SUNDRY NOTICES AND REPORTS ON WELLS (DO NOT USE THIS FORM FOR PROPOSALS TO DRILL OR TO DEEPEN OR PLUG BACK TO A DIFFERENT RESERVOIR USE "APPLICATION FOR PERMIT" (FORM C-101) FOR SUCH PROPOSALS)		WELL API NO. 30-025-39364 ✓

2. Name of Operator Devon Energy Production Company, LP		6. State Oil & Gas Lease No.
3. Address of Operator 20 North Broadway Oklahoma City, Oklahoma 73102-8260 (405) 552-8198		7. Lease Name or Unit Agreement Name Falcon 32 State ✓

Devon Energy Production Company, L.P. respectfully requests approval to change the Rig and BOPE description as follows:

# 13-5/8" x 5,000 psi BOP Stack

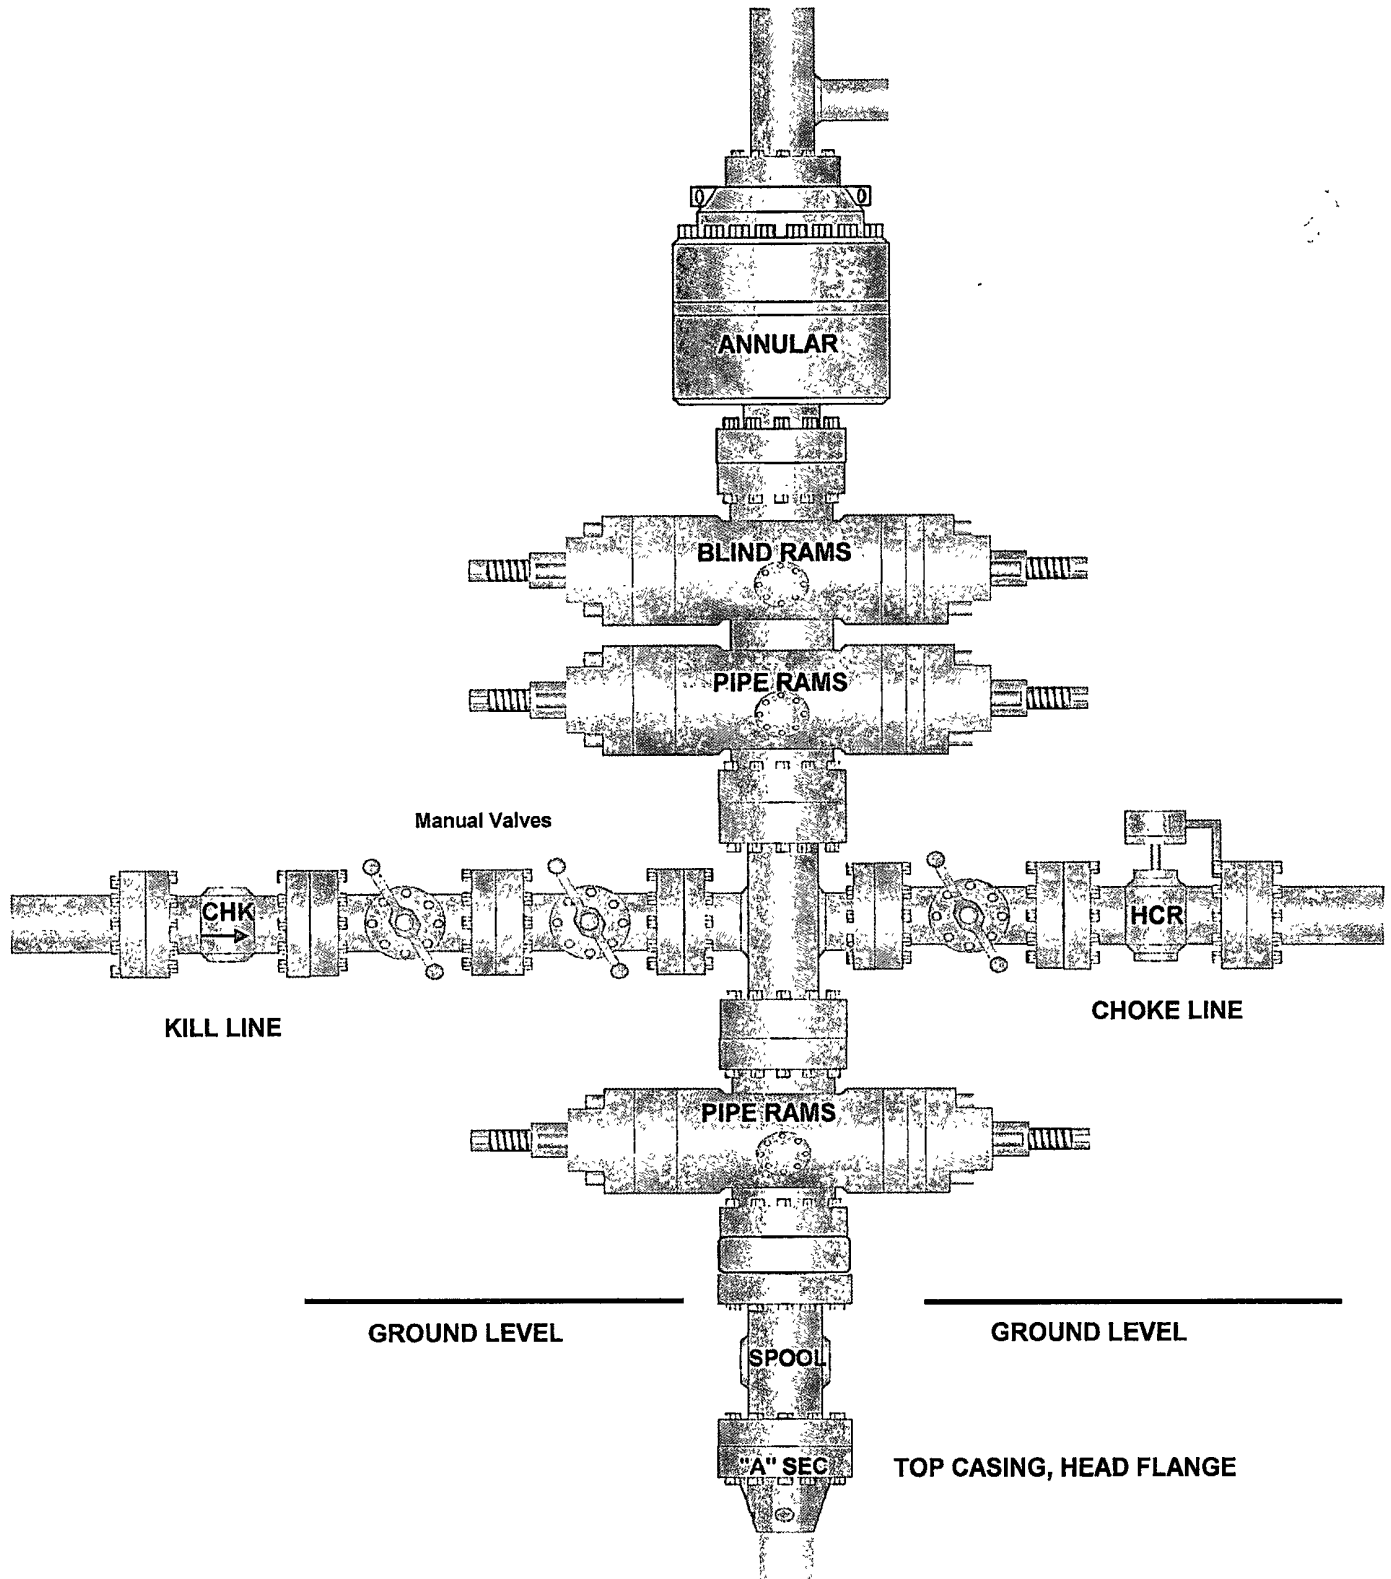
The BOP system used to drill the intermediate hole will consist of a 13-5/8" 5M Double Ram and Annular preventer. The BOP system will be tested as per BLM Onshore Oil and Gas Order No. 2 as a 3M system prior to drilling out the surface casing shoe.

The BOP system used to drill the production hole will consist of a 13-5/8" 5M Double Ram and Annular preventer. The BOP system will be tested as per BLM Onshore Oil and Gas Order No. 2 as a 5M system prior to drilling out the intermediate casing shoe.

The pipe rams will be operated and checked each 24 hour period and each time the drill pipe is out of the hole. These tests will be logged in the daily driller's log. A 2" kill line and 3" choke line will be incorporated into the drilling spool below the ram BOP. In addition to the rams and annular preventer, additional BOP accessories include a kelly cock, floor safety valve, choke lines, and choke manifold rated at 5,000 psi WP. (see attached BOP schematic)

## H&P 214 & 232 Location Dimensions

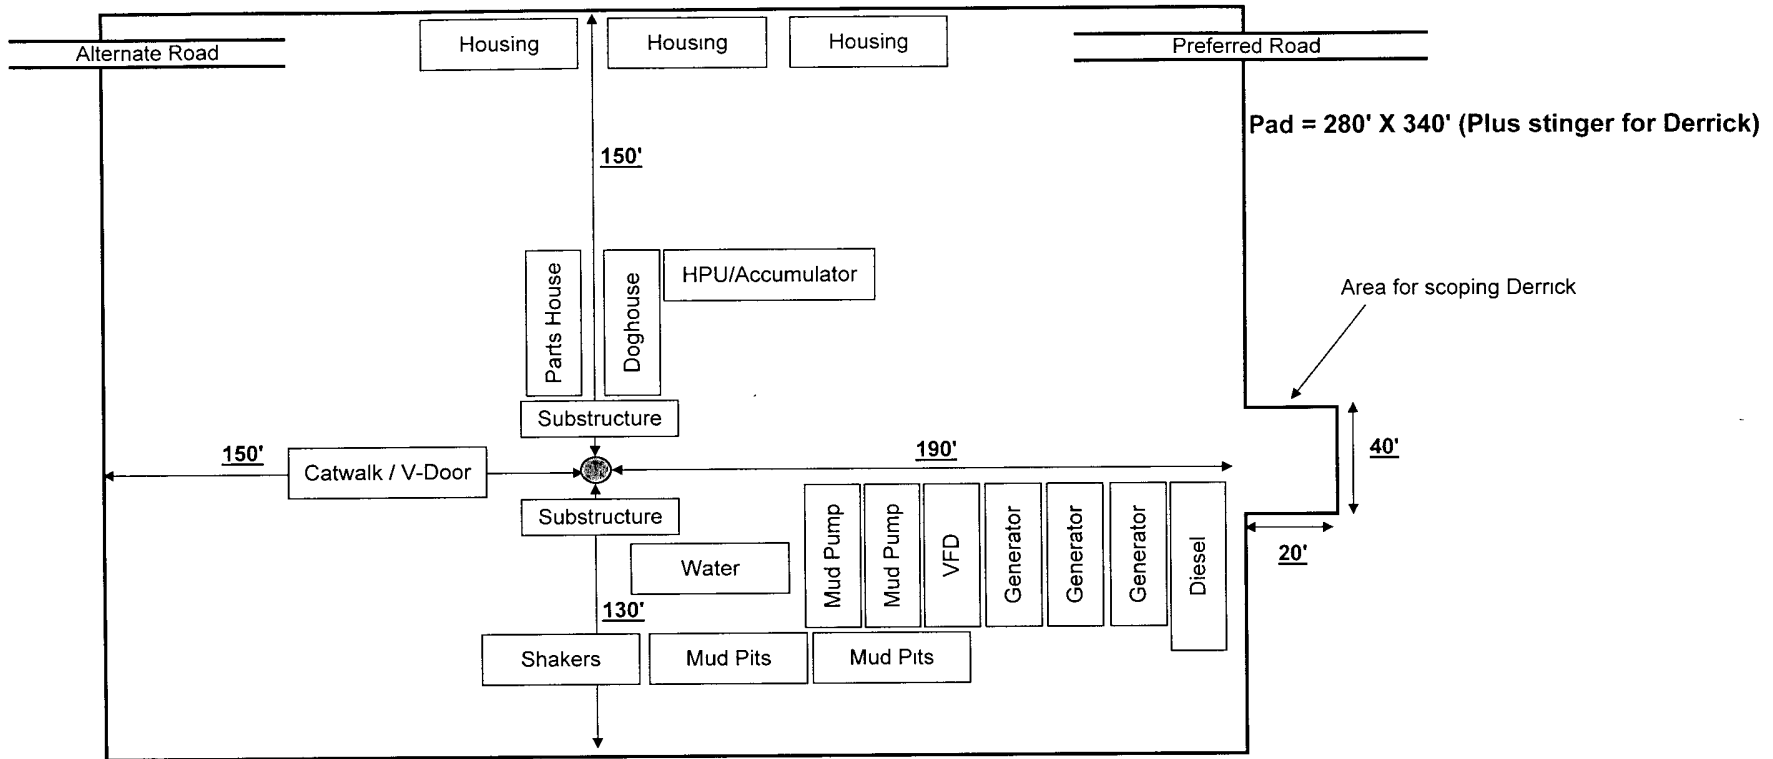
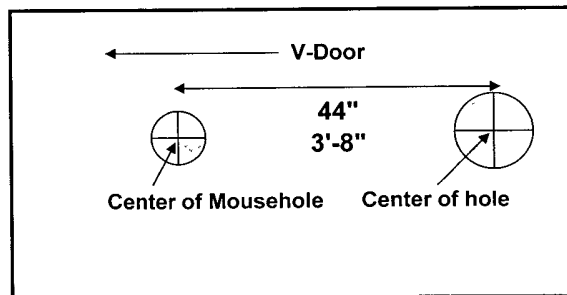
Rig Change to H&P Rig # 214 (see attached rig layout)
